**TOWN OF BAY HARBOR ISLANDS
MORRIS N. BROAD COMMUNITY CENTER
1175 95TH STREET
BAY HARBOR ISLANDS, FL 33154**

DESIGN REVIEW BOARD

**February 13, 2024
7:00 PM**

Subject: Site Development Plan Application – Exterior Renovations
Existing Multi-Family Residential Complex (9 DU)
1060 95th Street
Bay Harbor Islands Acct. No. SPR23-000027
MMPA Acct. No. 01-0702- 1171

1 (01) - 1ST FLOOR -EXISTING/ DEMOLITION PLAN-DRB-1
DRB.4.1 Scale: 3/32" = 1'-0"

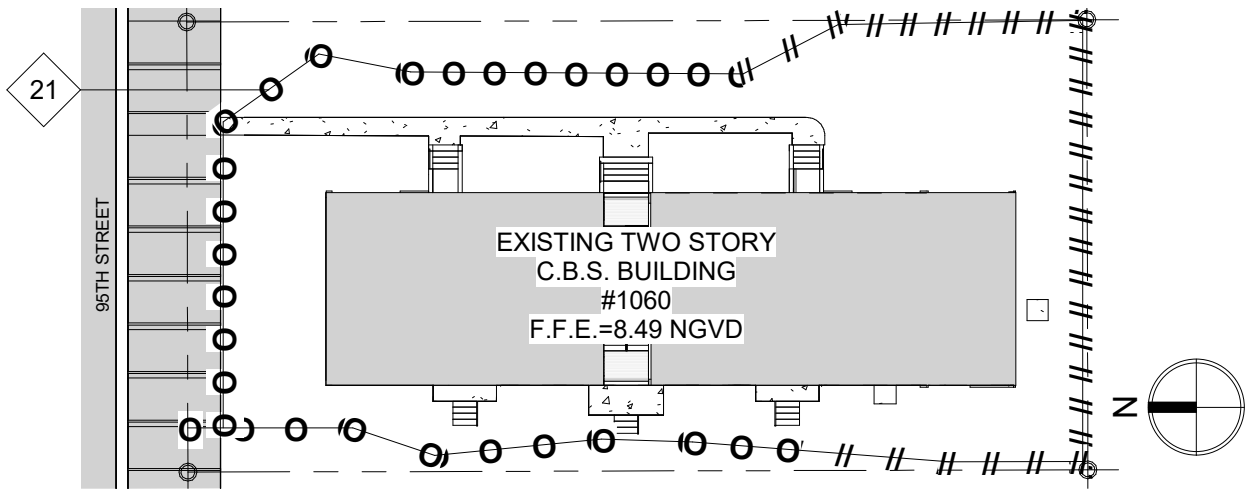
1. PLANS APPEAR TO INDICATE THAT ADDITIONS ARE BEING PROPOSED. PLEASE PROVIDE AND EXISTING AND PROPOSED PLAN.
7.What is the purpose of the temporary fence? Is this simply to secure the site at present?

1 (02) - 2ND FLOOR -EXISTING/ DEMOLITION PLAN-DRB-1
DRB.5.1 Scale: 1" = 10'-0"

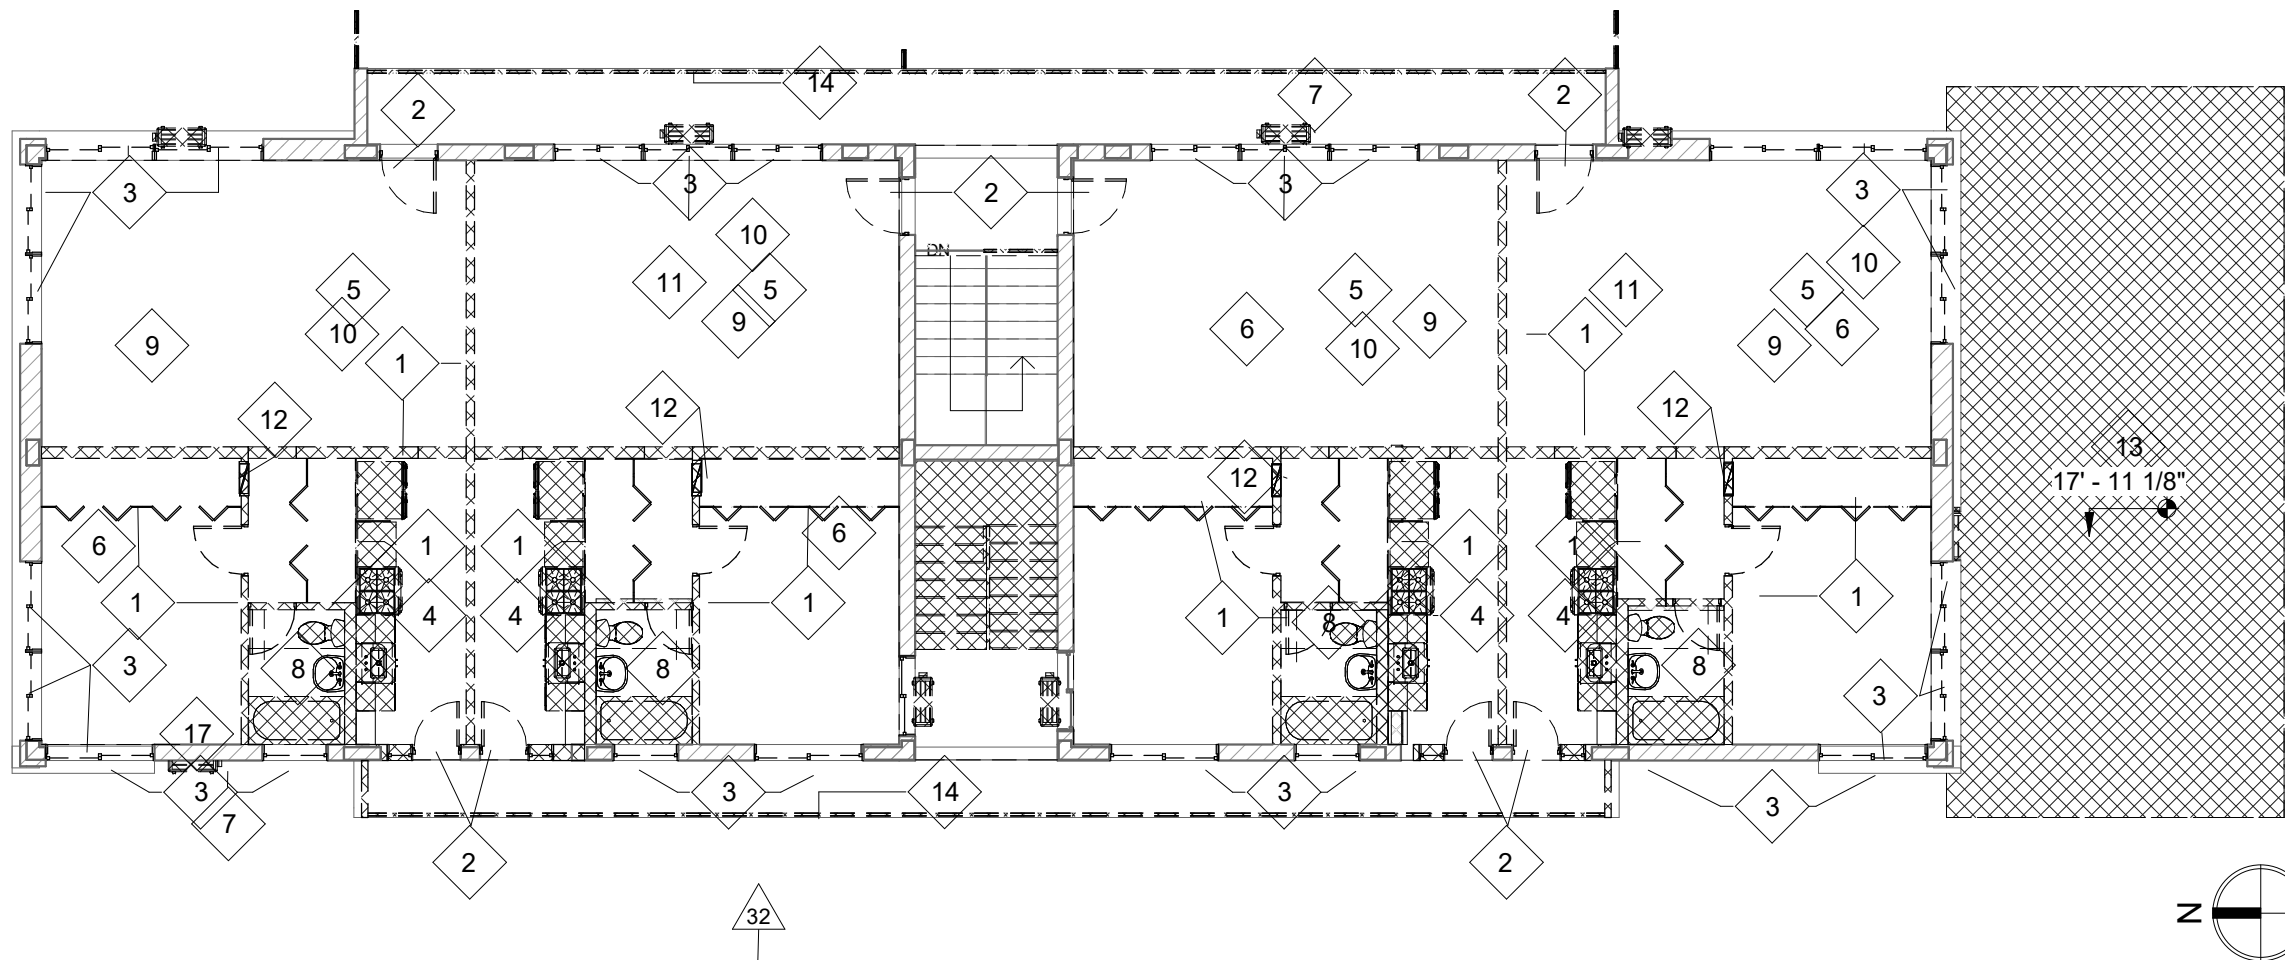
1. PLANS APPEAR TO INDICATE THAT ADDITIONS ARE BEING PROPOSED. PLEASE PROVIDE AND EXISTING AND PROPOSED PLAN.

DRB.6

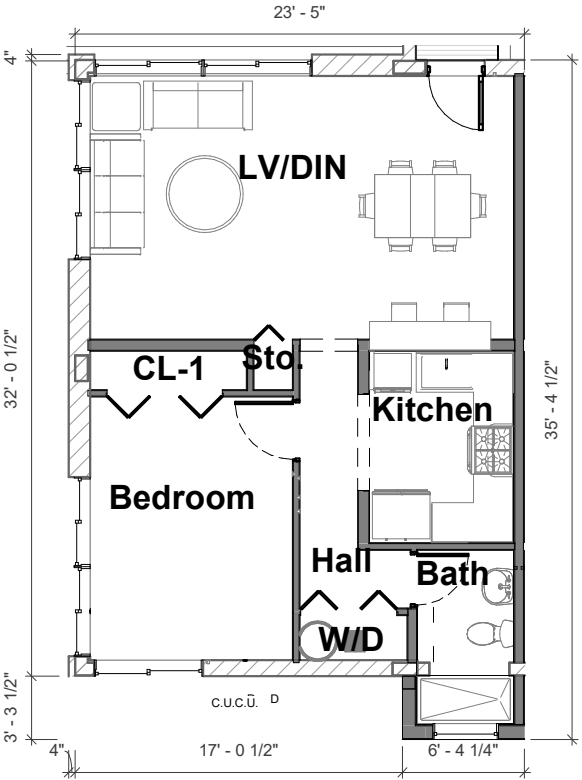
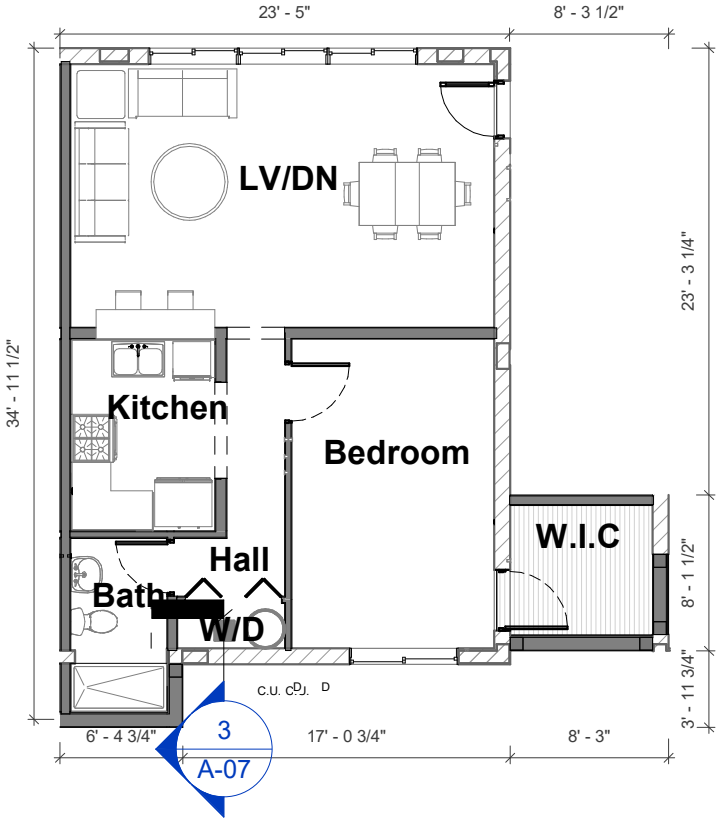
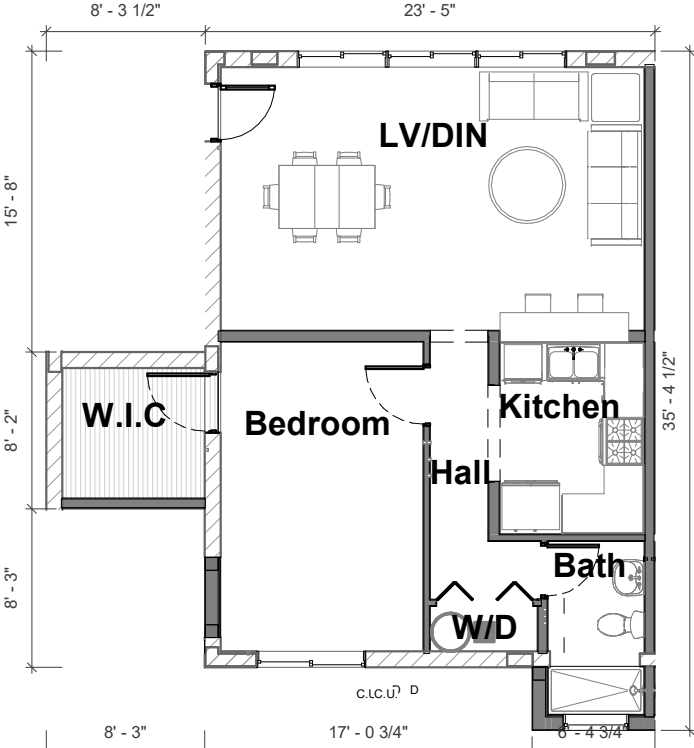
Revision Number	Revision
51	B.Provide a table listing each DU noting the number of bedrooms / bathrooms / square footage/

TYP FLOOR PLANS-B

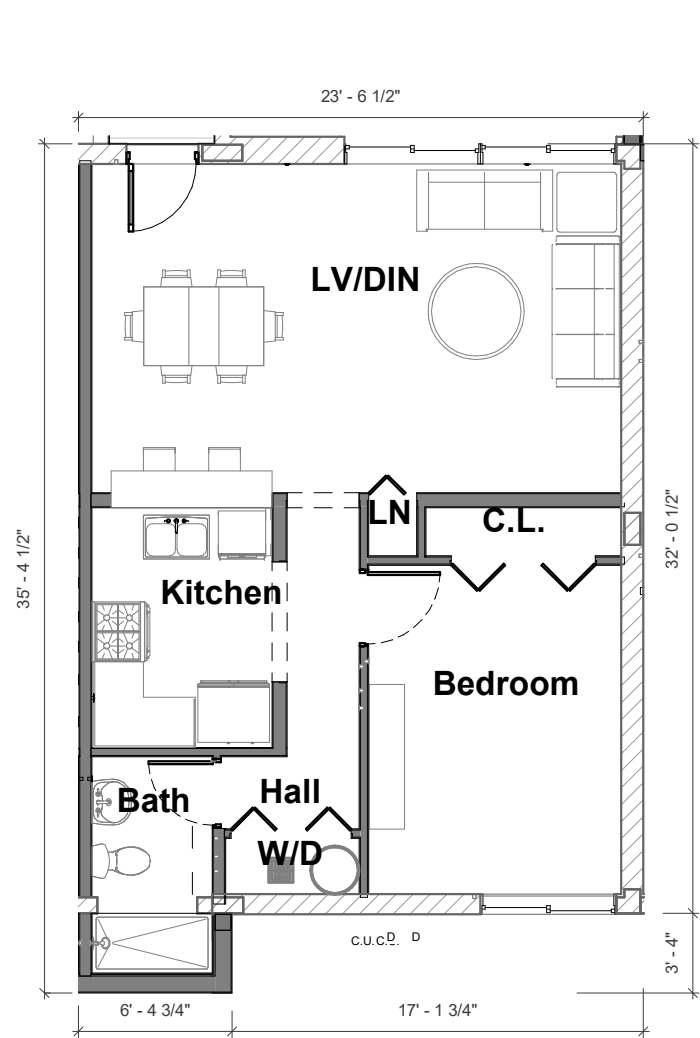
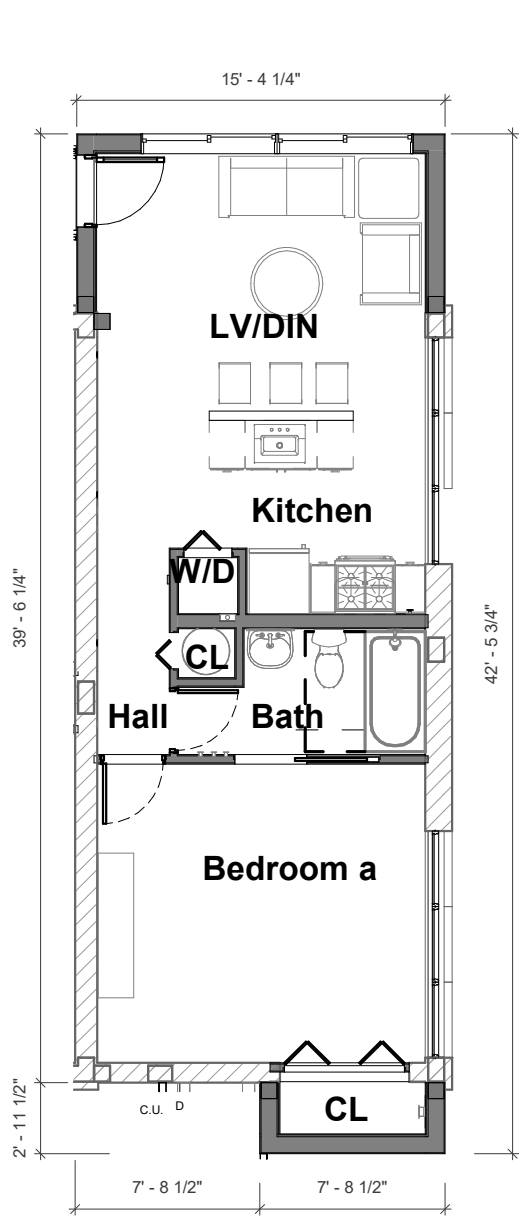
Revision Number 51 B.Provide a table listing each DU noting the number of bedrooms / bathrooms / square footage/

1 Wall section - Proposed addition - DRB
DRB.6.2 Scale: 1/2" = 1'-0"

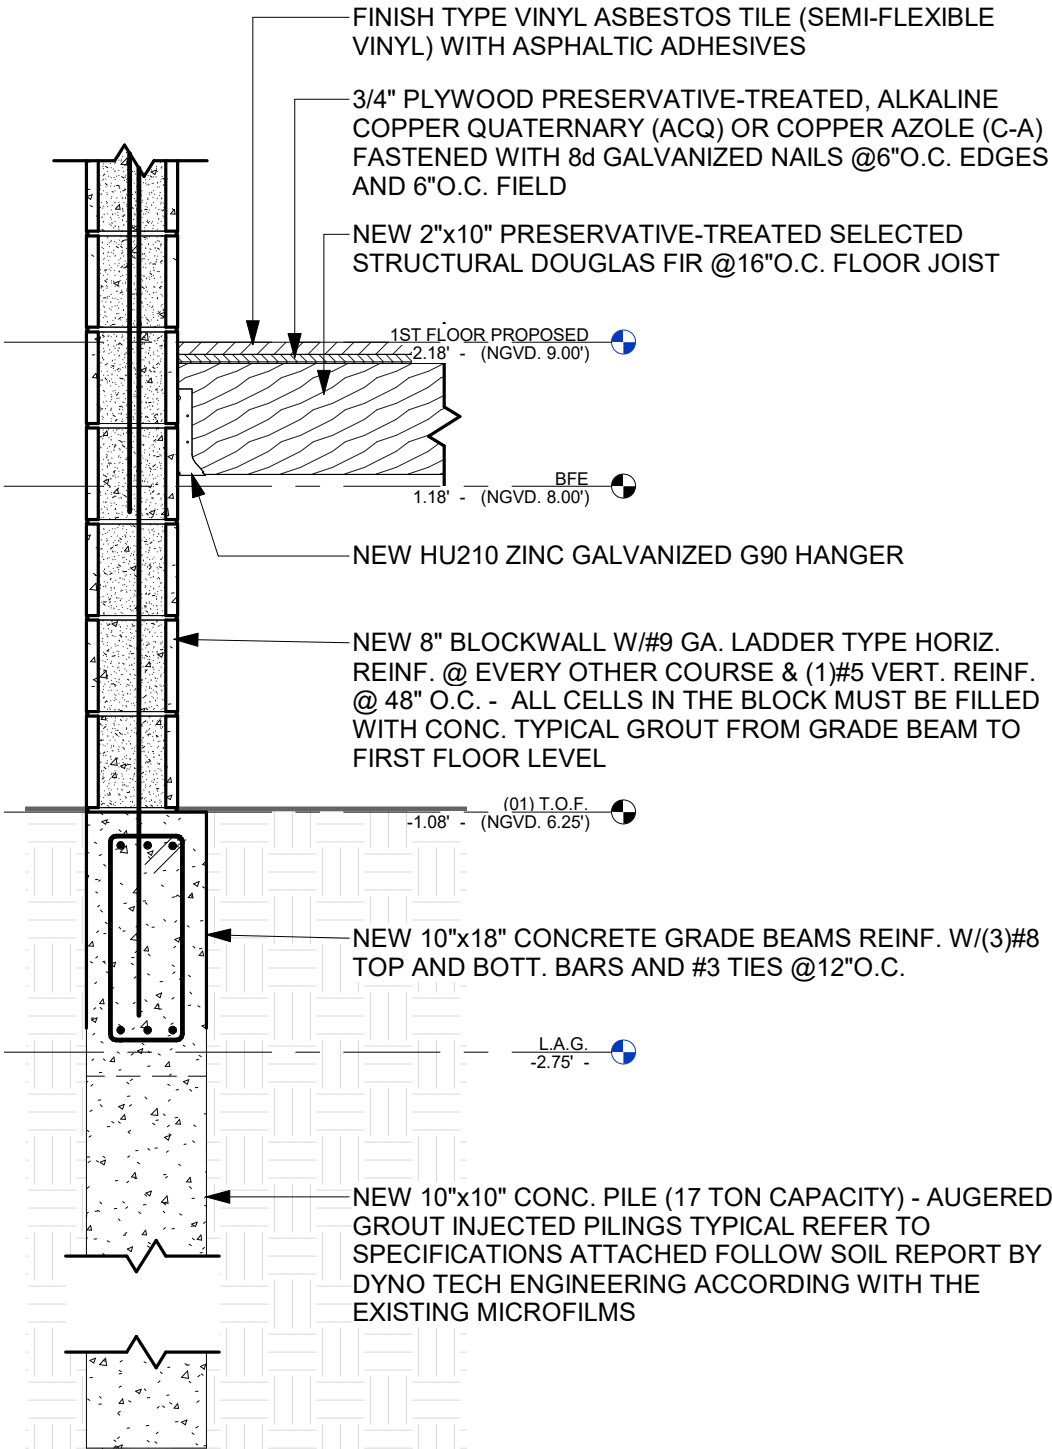
Revision Number 55 5. Provide details on proposed 115 Square foot addition covered area.

EAST ELEVATION

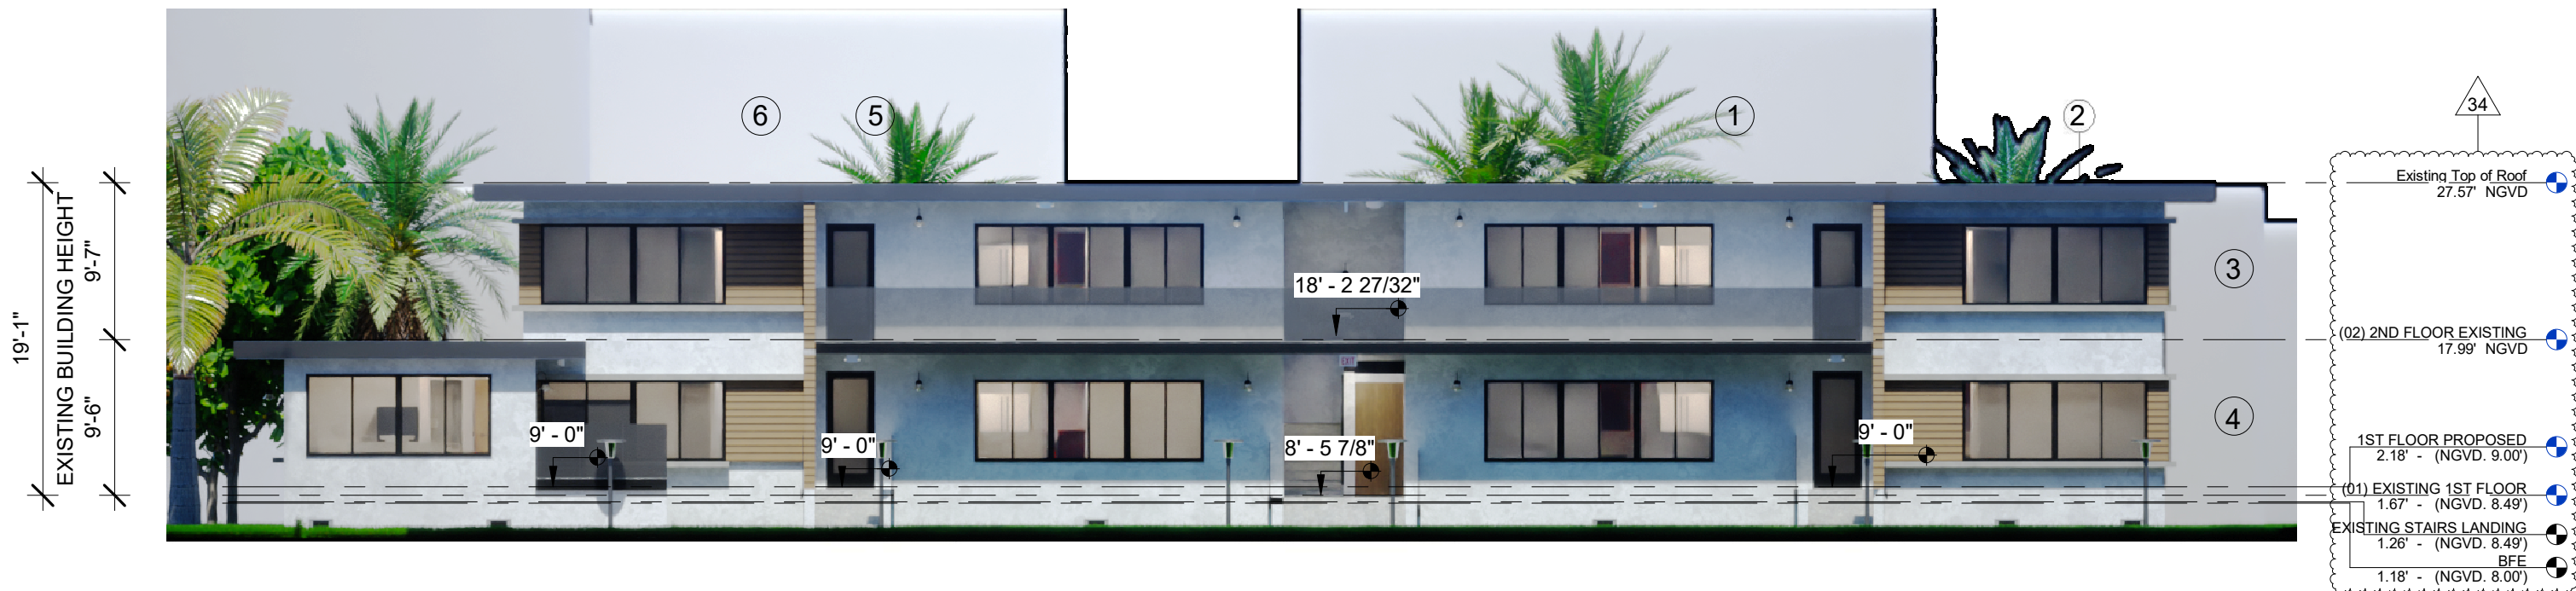
3. SHOW ALL PROPOSED ELEVATIONS (INCLUDING FINISHED FLOOR AND EQUIPMENT SERVICING THE BUILDING, GARAGE FFE, ETC). SHALL COMPLY WITH THE REQUIREMENTS IN ASCE 24,FEMA AND FBC. -ADDITIONAL COMMENTS MAY BE PENDING AFTER REVIEW OF THE REQUESTED DOCUMENTS AS LISTED ABOVE.
10. While pictures have been provided the code normally requires colored building elevations for all 4 sides of the building. Since there are minimal exterior changes perhaps a better representation would suffice due to the expense of renderings.
